# Harmony Ranch Subdivision Improvement Plans

WEBER COUNTY, UTAH  
APRIL 2021

**Harmony Ranch Subdivision**  
 WEBER COUNTY, UTAH  
**Cover/Index Sheet**

Street Section (50' R.O.W.) Private Road

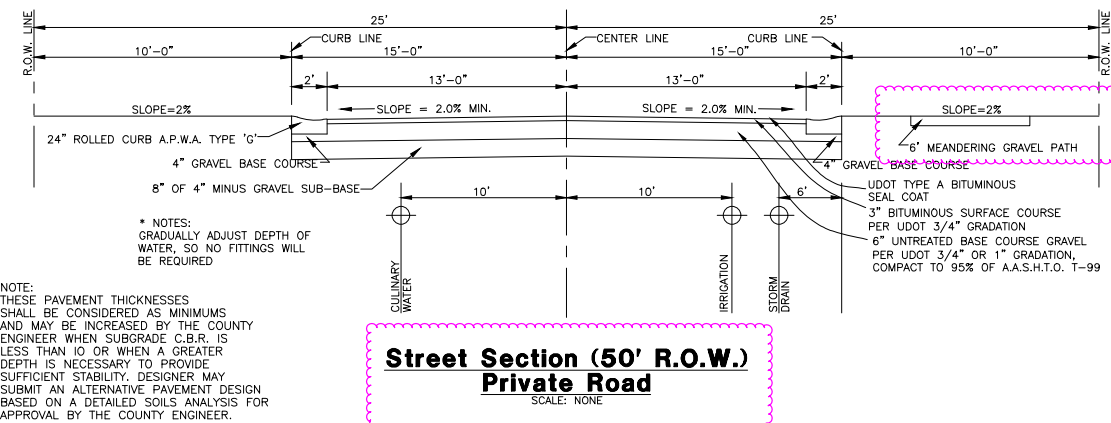
Update labels and widths

Adjust to match with plans

**STREET A 1+00.00 - 10+50.00**

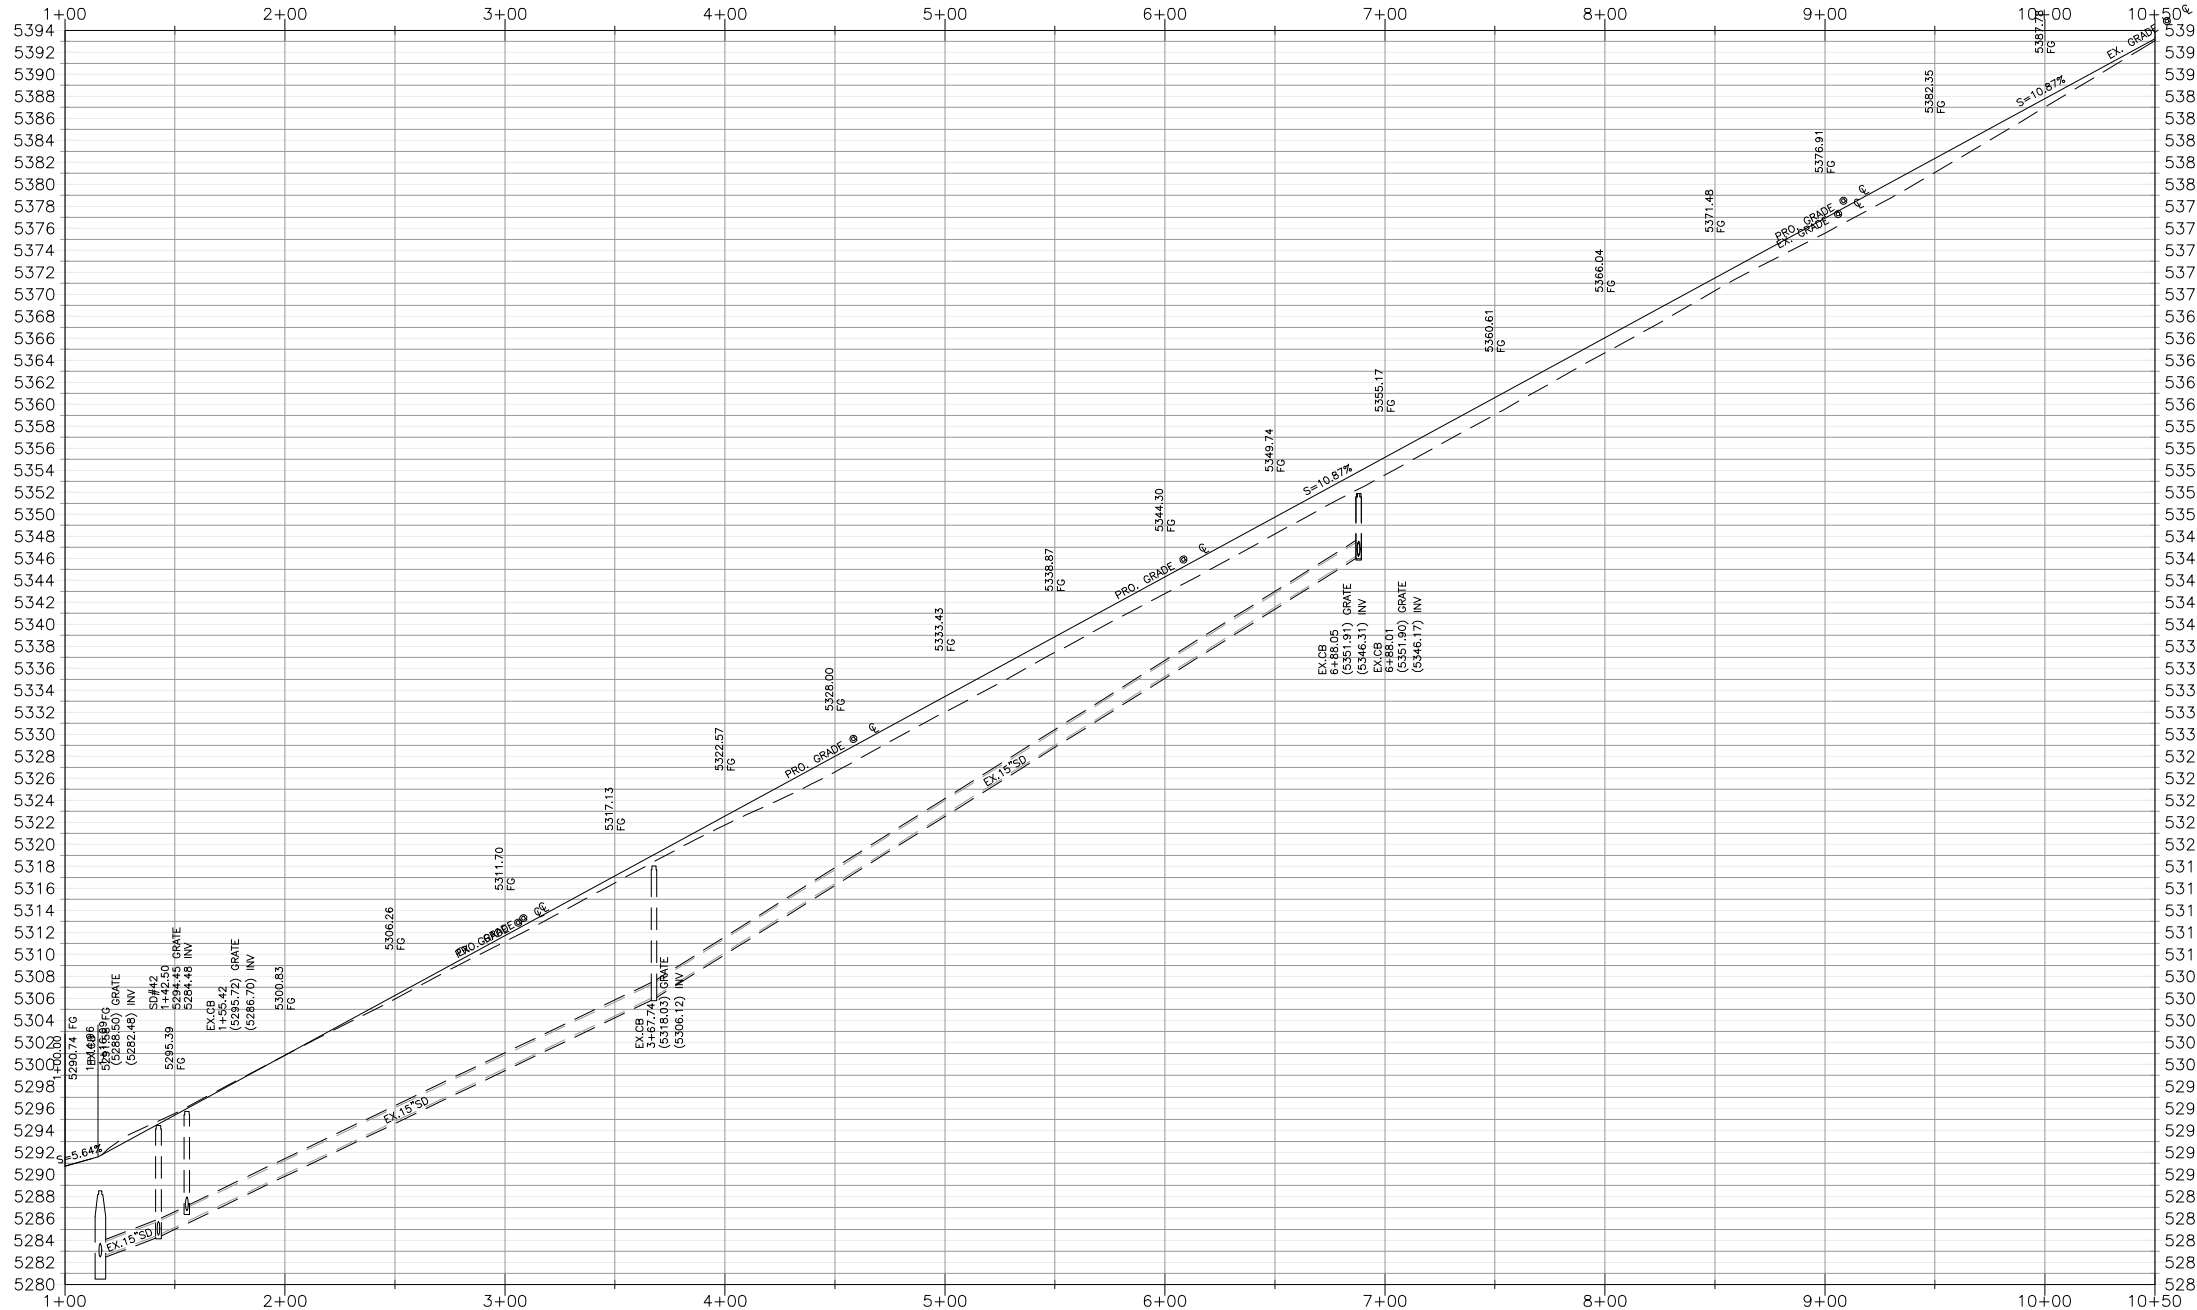
double inlets

**STREET A 10+50.00 - 13+25.55**

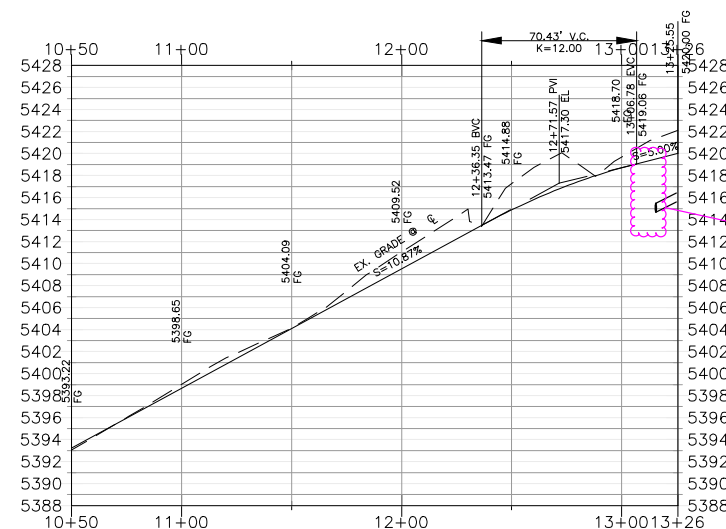
Outside of property lines

Is a SD box missing?

**STREET C 1+00.00 - 5+45.24**

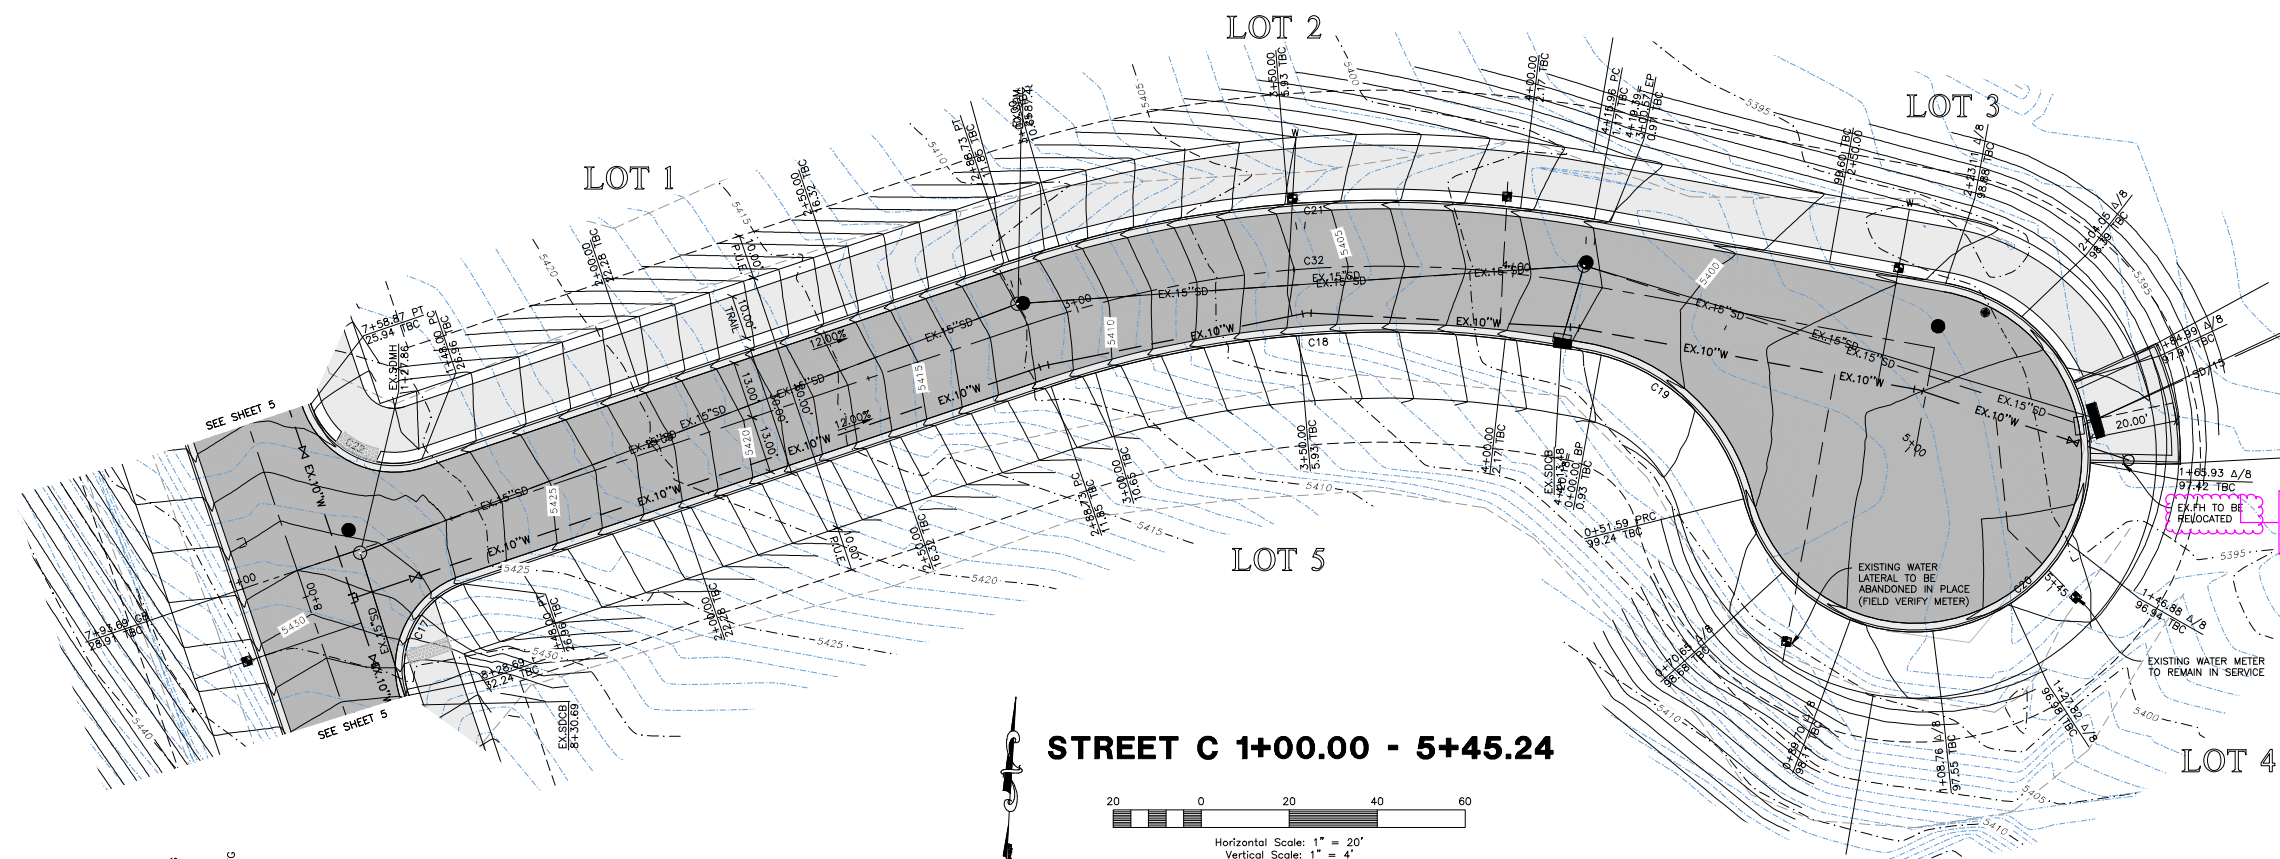
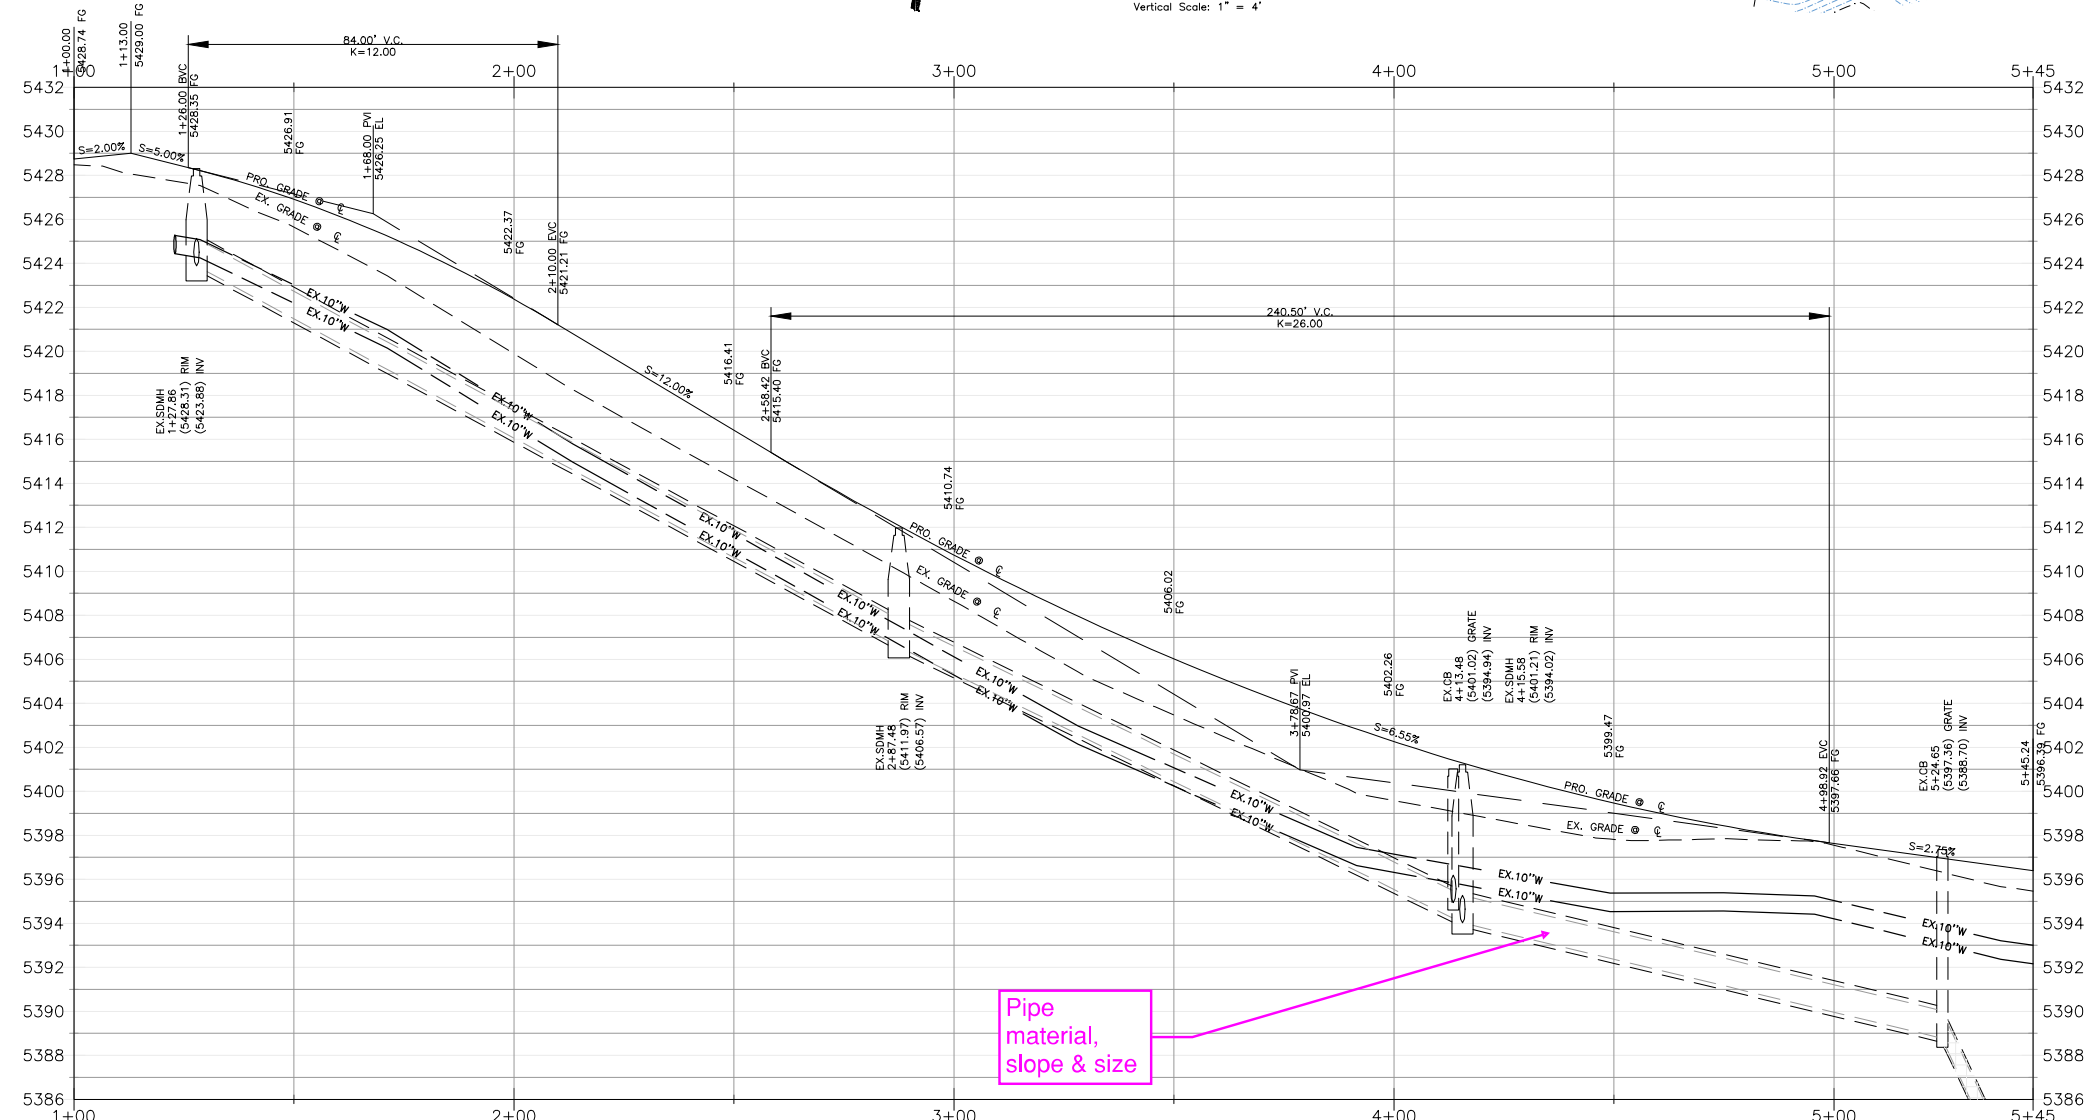
Relocated to where?

Pipe material, slope & size

**STREET D 1+00.00 - 4+13.78**

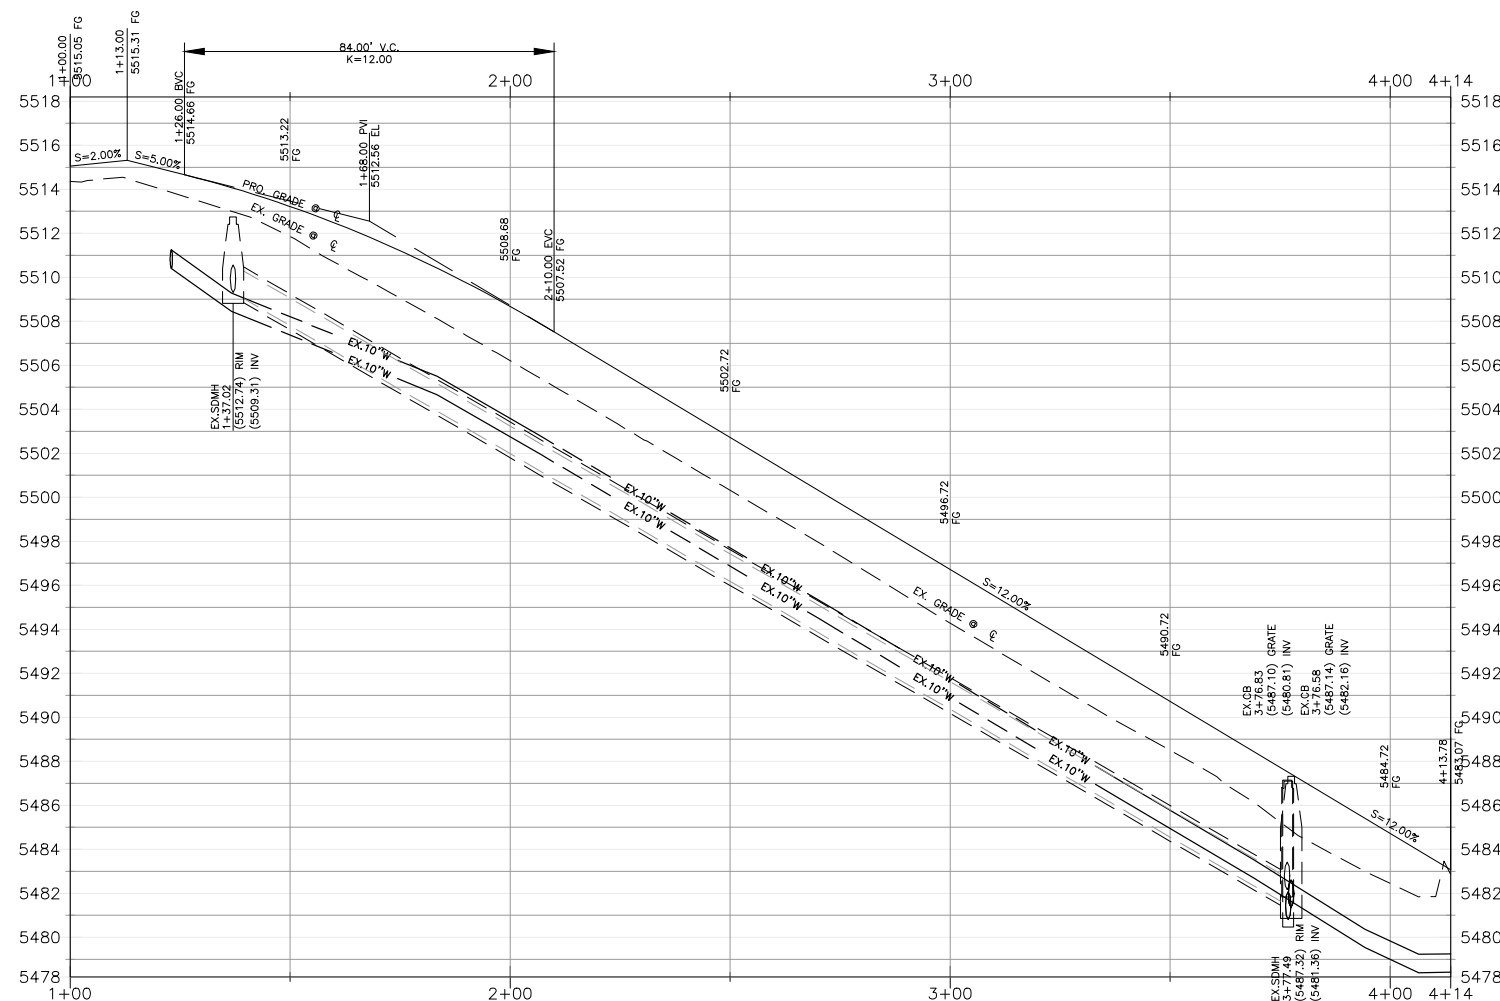
What surface improvements will be installed for the temporary turnaround.

Please cleanup the structures, it is not clear how many inlets are existing.
